PHOTOGRAPHS

PHOTOGRAPH #23

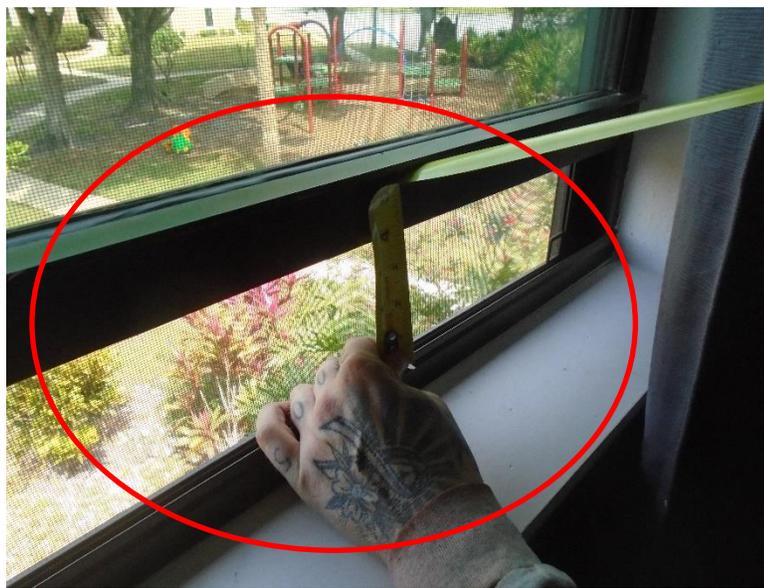
Window Operation Control Device installed in accordance with FBC 2017 complying with ASTM F2090.
